May 10, 2021

From: Martin Green, PhD
Email: magreen@sympatico.ca

Re: Item EY24.4: **250 Wincott Drive and 4620 Eglinton Avenue West -
Zoning By-law Amendment Application - Final Report**
Etobicoke York Community Council, May 17, 2021

SITE PLAN

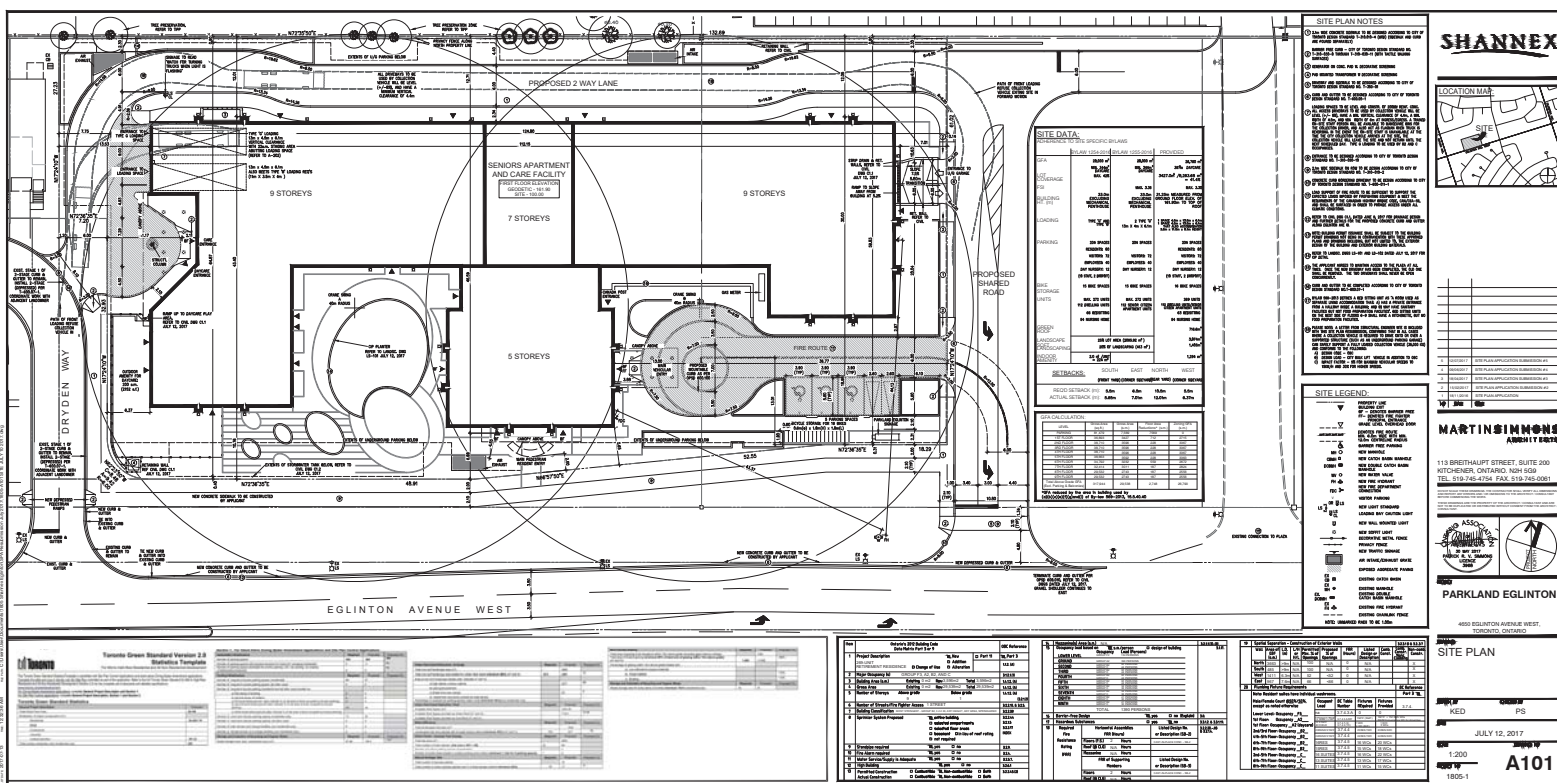
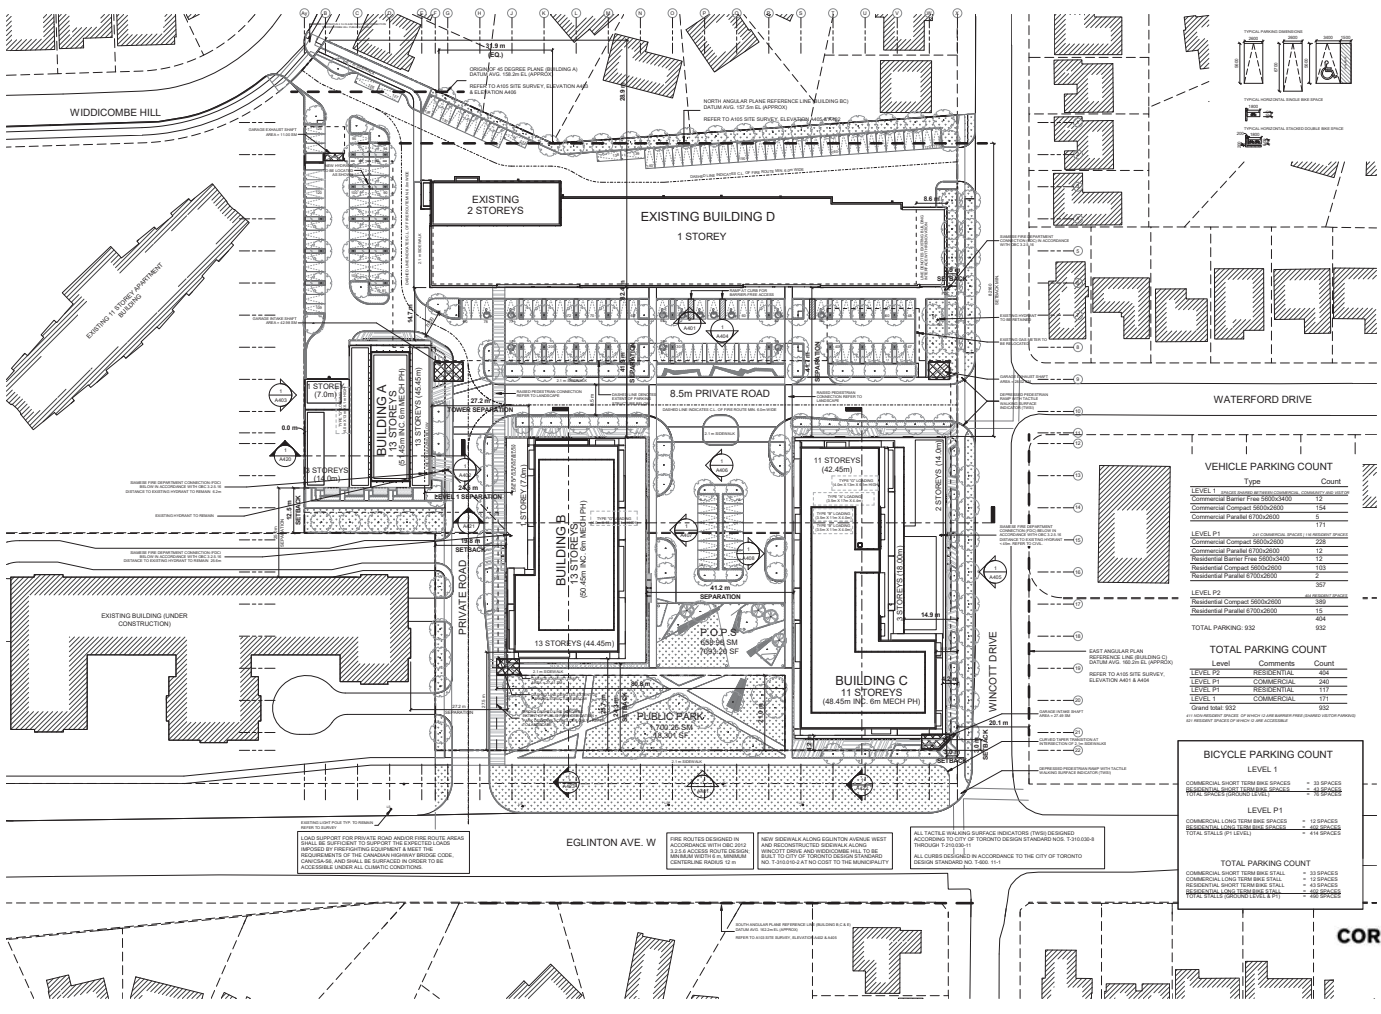
Through several follow-up email exchanges, it became apparent that the above assertion about the parking garage was based on a July 2017 site plan drawing for the Shannex seniors building at 4650 Eglinton Avenue West, **not the present application**. The site plan submitted for the present application shows the proposed new road shifted eastward by 4 to 5 metres. The boulevard no longer extends over the adjacent property and its underground garage – the (potential) encumbrance is eliminated by the present site plan. Both drawings are included in Appendix 2.

But the Senior Engineer persisted, sending another drawing that shows a stormwater management system – drains, manholes, holding tank and connecting pipes – located under the private road. None of this extends over the adjacent (Shannex) property, and its primary purpose is to manage stormwater flow for the recently-built private road itself.

The reader is reminded that the present application requires the private street to be moved about 5 metres eastward, so the existing stormwater management system will need to be replaced or substantially modified in any case.
